Re: Irigaray and Christensen Ranch Uranium Project
License Amendment Request
Materials License No. SUA-1341
Docket No. 40-8502

Uranium One USA, Inc. (Uranium One) requests an amendment of materials license SUA-1341 for the Irigaray and Christensen Ranch (jointly referred to as Willow Creek) Uranium Project. The purpose of this amendment request is to change two provisions of the license:

MATERIALS LICENSE SUA-1341 LICENSE AMENDMENT REQUEST TECHNICAL AND IMPACT ANALYSIS

SUA-1341 January 5, 1996 License Renewal Application
February 4, 2011 Amendment Request
Page Replacement Directions

Irigaray Processing Facility
General Plant Arrangement

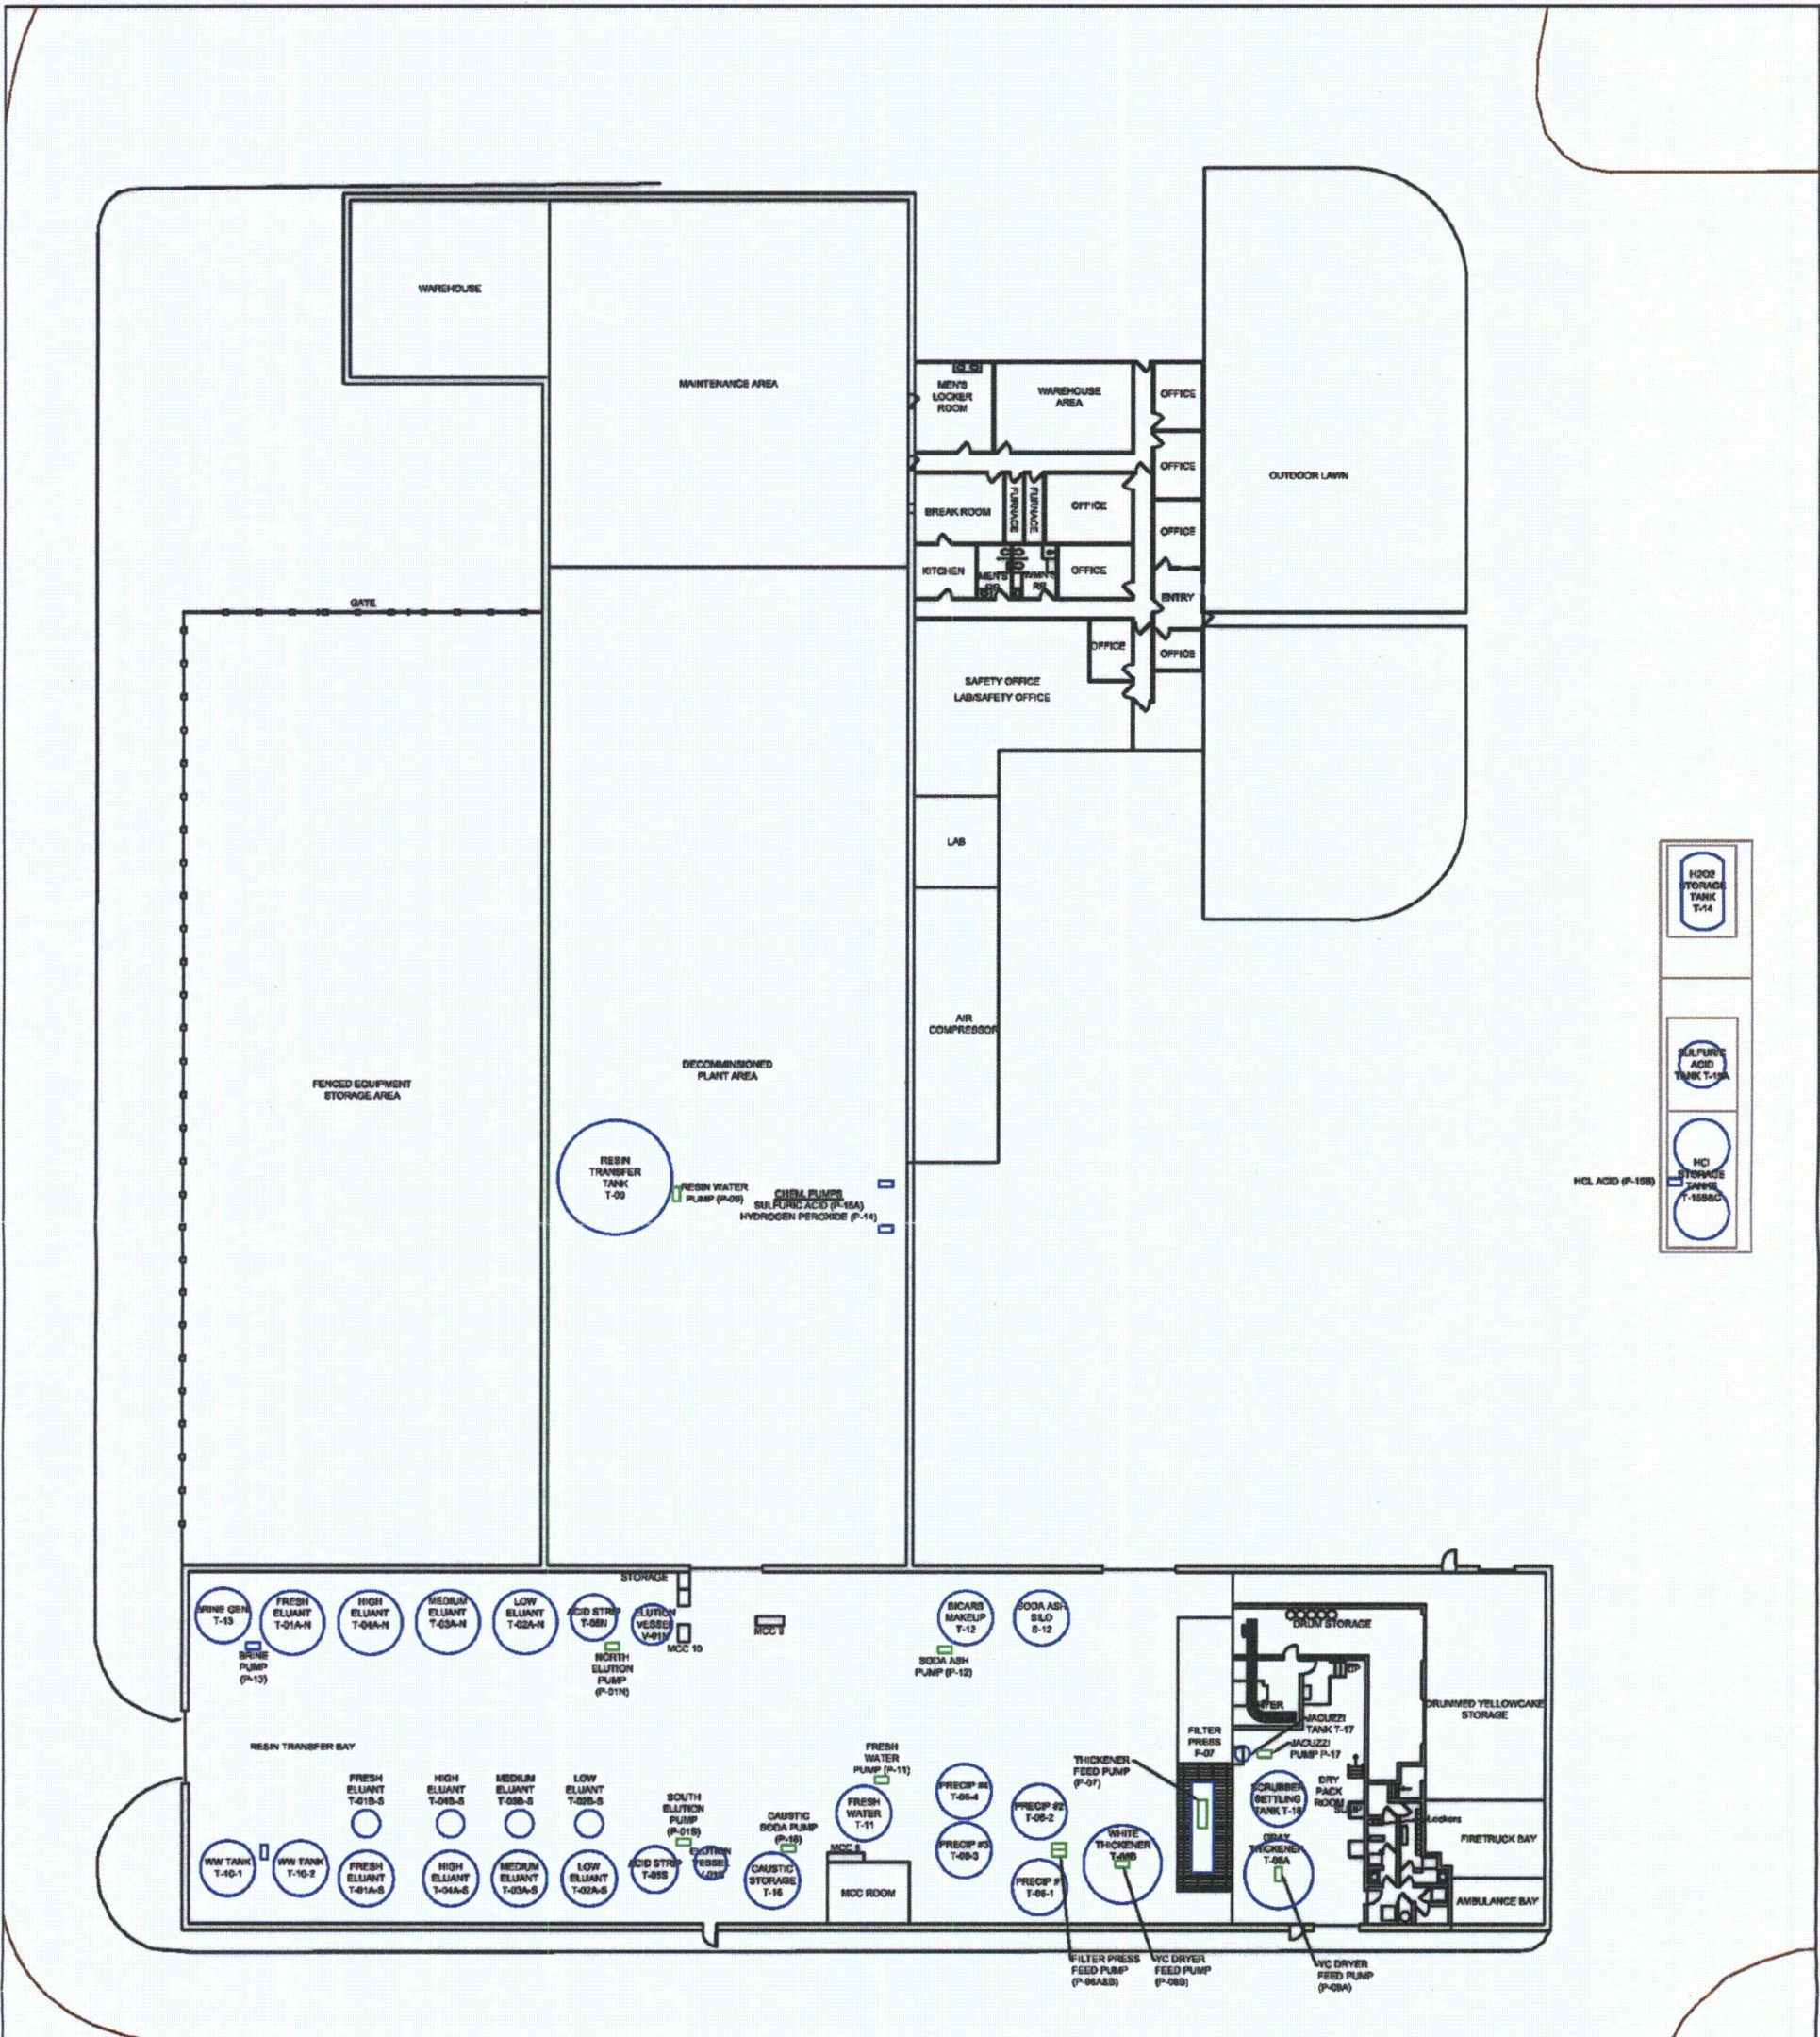
Figure 3.9 depicts the general arrangement of the Irigaray central plant. When the Irigaray plant was first constructed in 1977, the main plant contained a 1,600 gpm up-flow capacity ion exchange circuit (operated at 800 gpm) with accompanying resin transfer and elution columns, precipitation system, calcium clarifiers, lixiviant make-up and the multi-hearth calciner for drying. In 1988, additional processing equipment was installed in the annex to the main plant, consisting of a 2,400 gpm ion exchange circuit, elution circuit, precipitation circuit, and yellowcake dewatering capability (uranium thickeners and filter press). At the same time, the Christensen resin transfer and elution systems were installed in the annex. The portion of the plant termed "main plant" has not been used since 1982, and now houses only the transfer water holding tank and the chemical transfer pumps for sulfuric acid and hydrogen peroxide. The hydrochloric acid pump is located outside the main plant. The old portion of the plant is also used for storage of byproduct material, and will be used for a vanadium removal circuit, if deemed necessary in the future.

If vanadium removal from the Christensen Ranch product is necessary, a specialized circuit will be installed at the Irigaray central plant. Equipment required for the vanadium separation will consist of two precipitation tanks, two smaller tanks for chemical additions and solution overflow and a vanadium filter press. The vanadium separation equipment will be located in the old plant area next to one of the clarifier units used for yellowcake storage. The vanadium separation area is shown on the Irigaray general arrangement diagram provided as Figure 3.9.

Rev. No.	By: CM	Description	Checked:	Approved:	Date	By
0		Initial Draft			10/25/10	CM
1		Moved HCl Pump			11/16/10	CM

Igaray Processing Facility
Process Flow Diagram

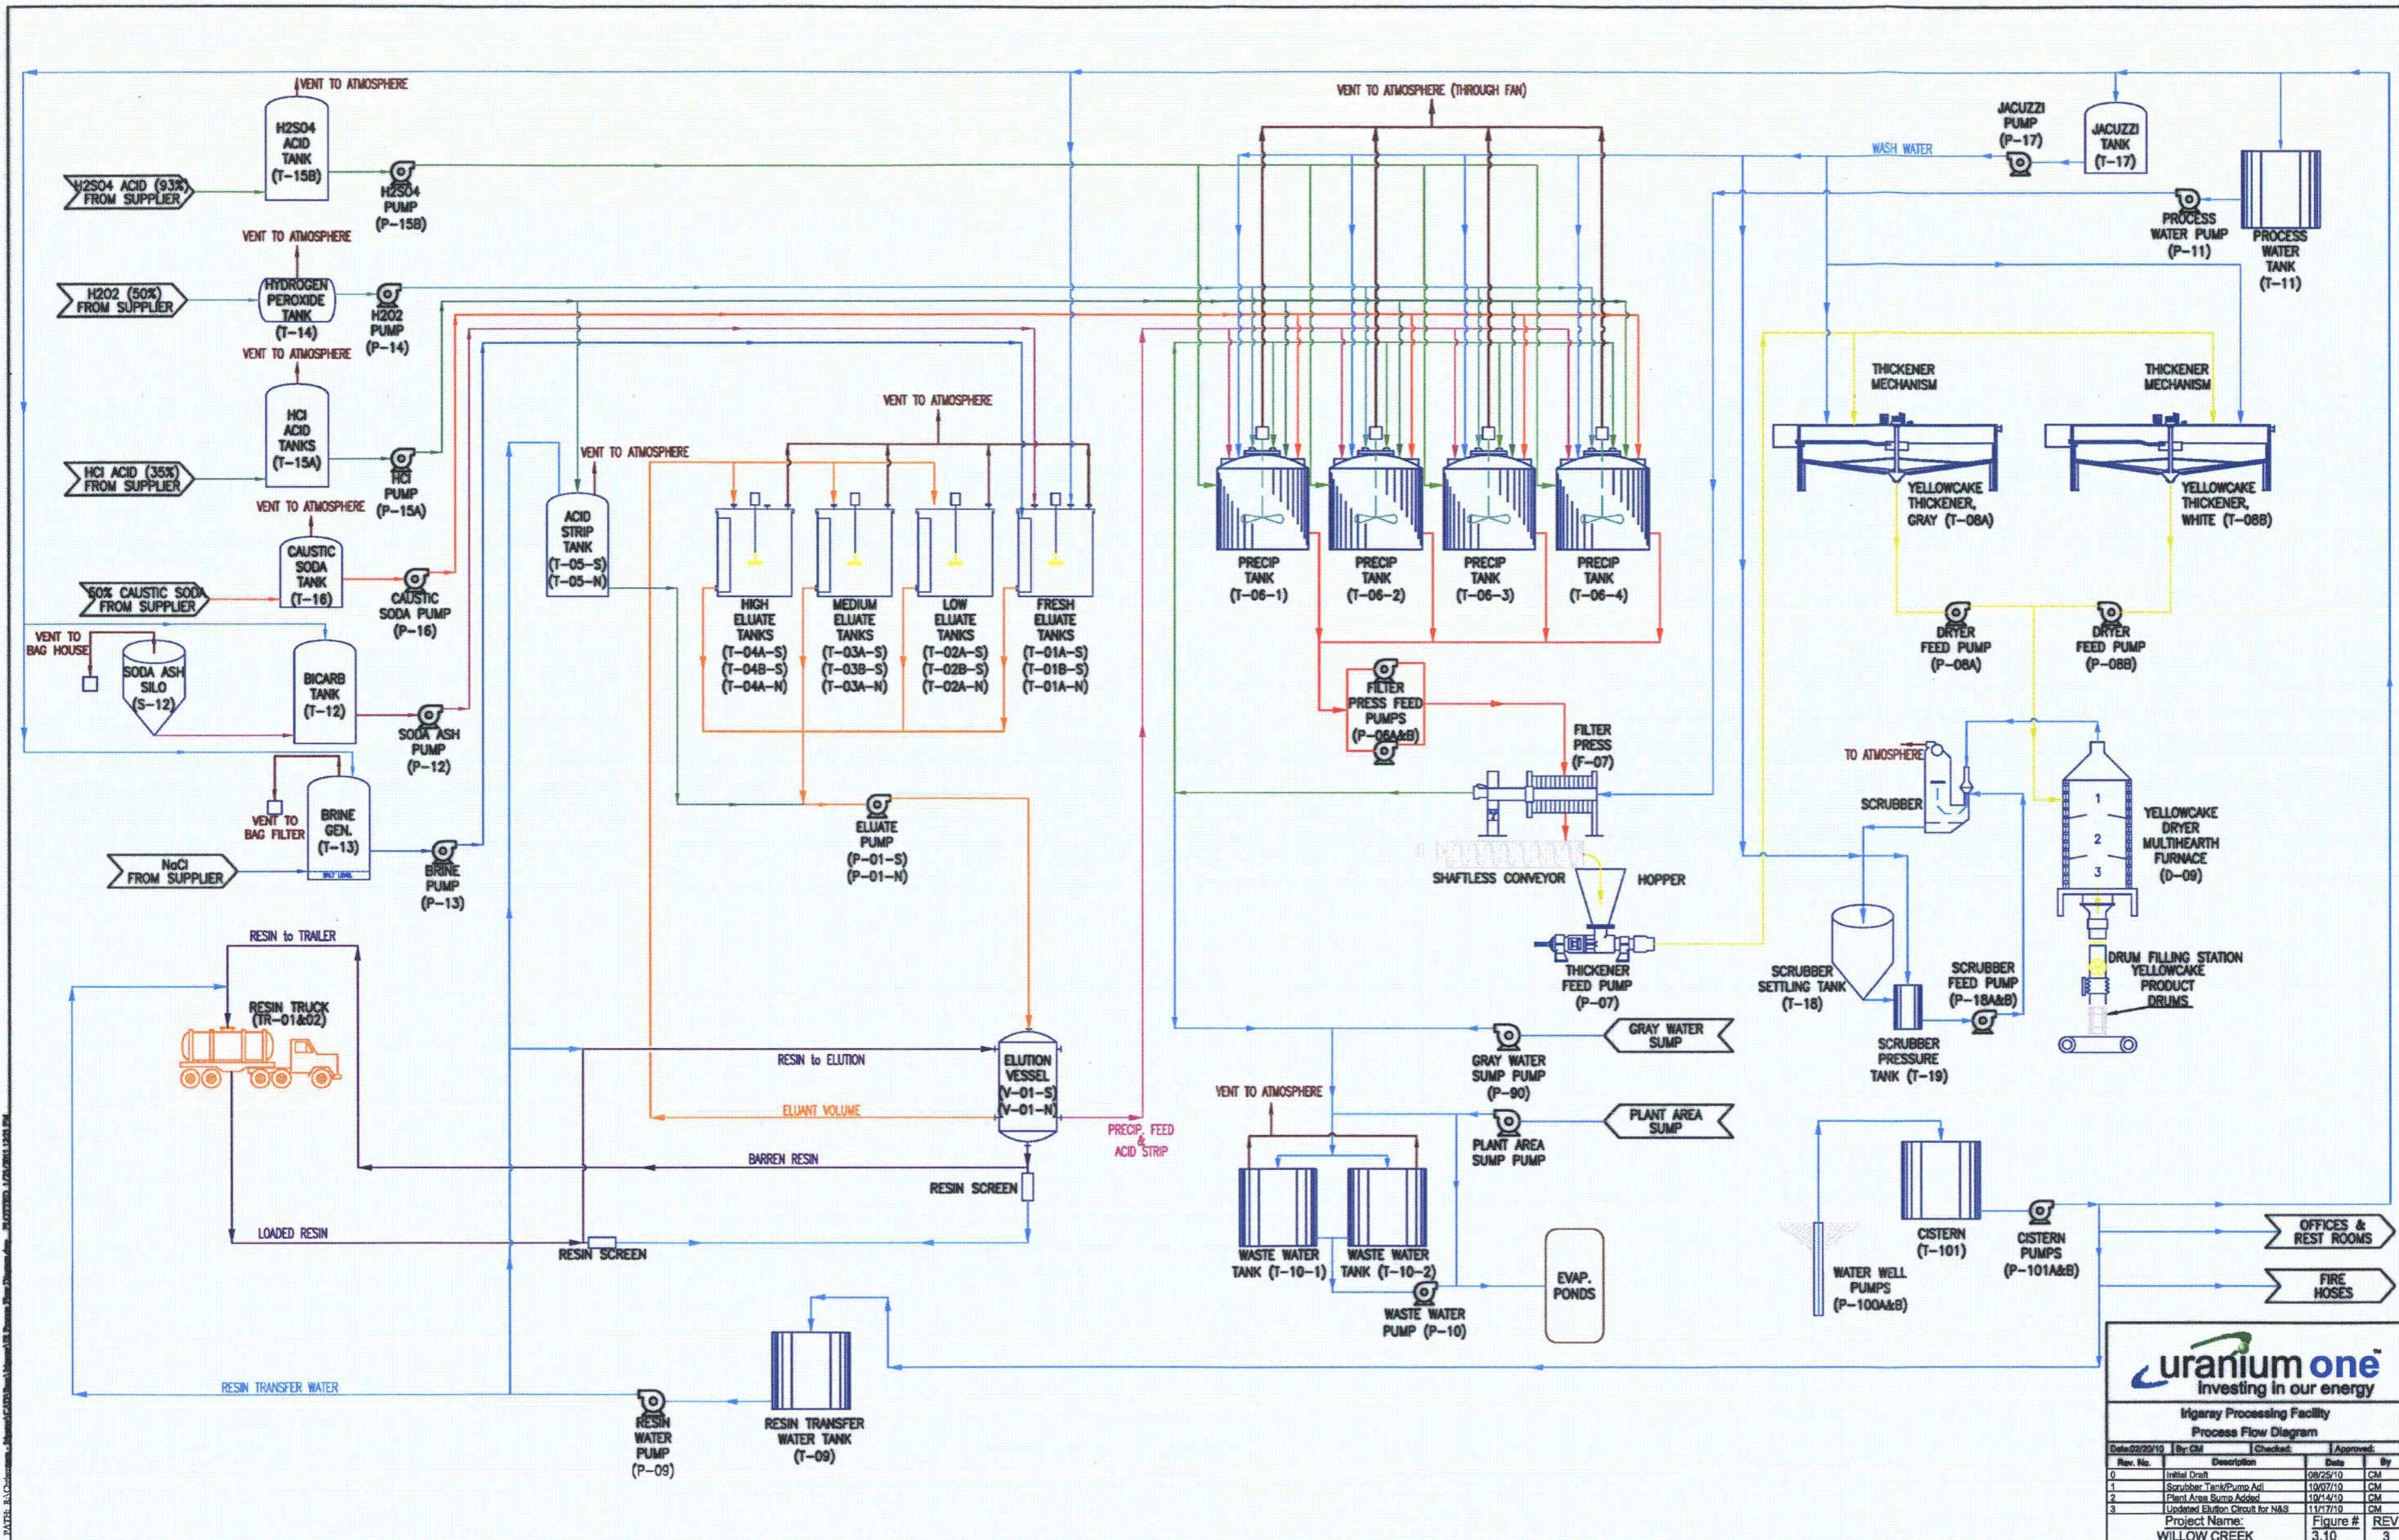
The process flow diagram for the Irigaray central recovery plant is provided as Figure 3.10. The figure assumes a 2400 gpm recovery flow from operating mine units. A 1% bleed rate from the well field is used, which is taken from the processing of 50 gpm of barren lixiviant through a reverse osmosis unit, with a resultant 25 gpm brine flow to disposal (1% bleed) and 25 gpm of high quality permeate, which is used for lixiviant makeup.

Rev. No.	Description	Date	By
0	Initial Draft	08/25/10	CM
1	Scrubber Tank/Pump Add	10/07/10	CM
2	Plant Area Sump Added	11/14/10	CM
3	Updated Elution Circuit for NAB	11/17/10	CM
